BZA-2031
THETA NU HOUSING, LLC
(variance)

STAFF REPORT
February 20, 2020

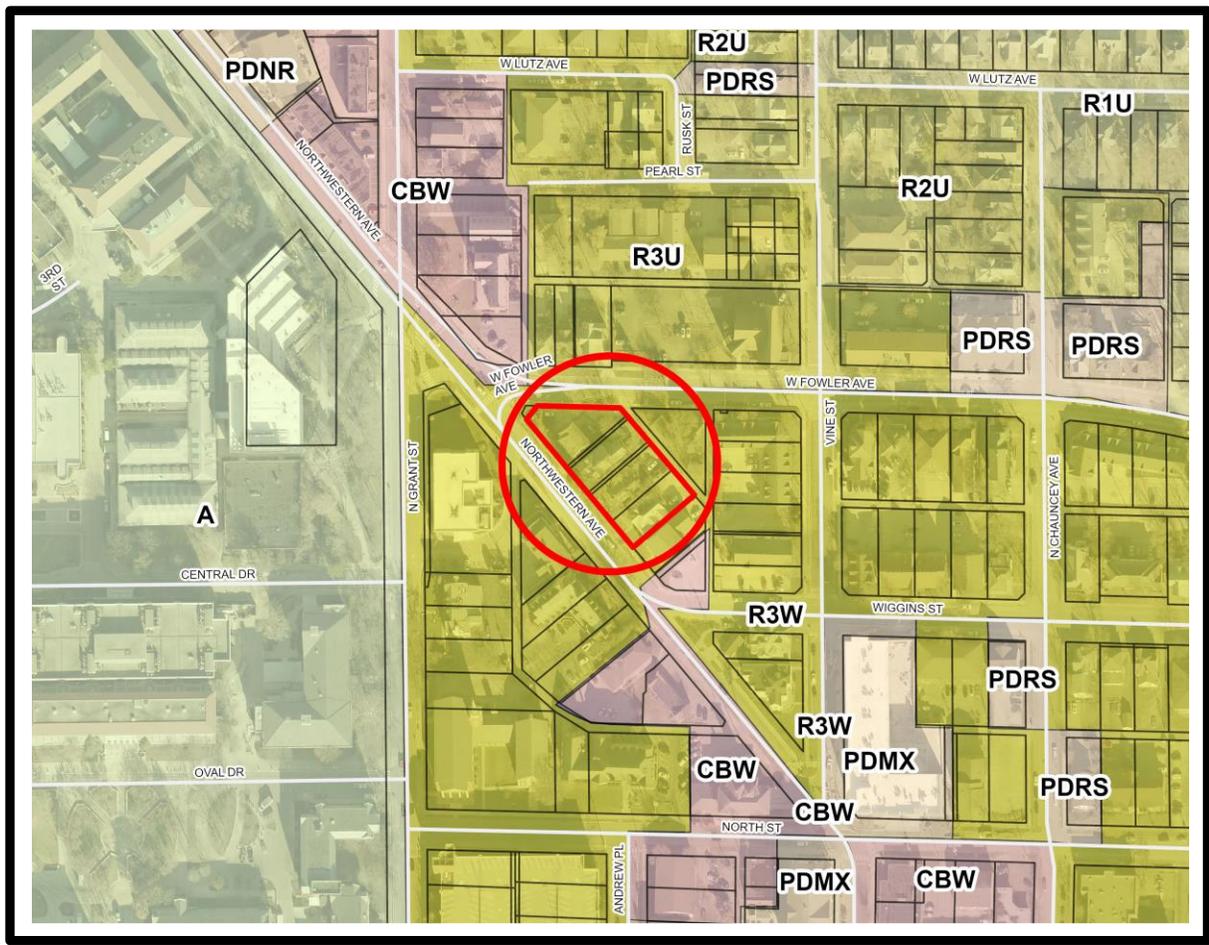
The petitioner is requesting a three-story building that has a height of 28' measured at the third story floor. Most new structures in the near campus area are a minimum of 3 floors. Recent discussion has focused less on the height and more on the usable floors of the structures. Staff has been able to support variances associated with three story developments; the proposed overall height of the building in this request is 56'.
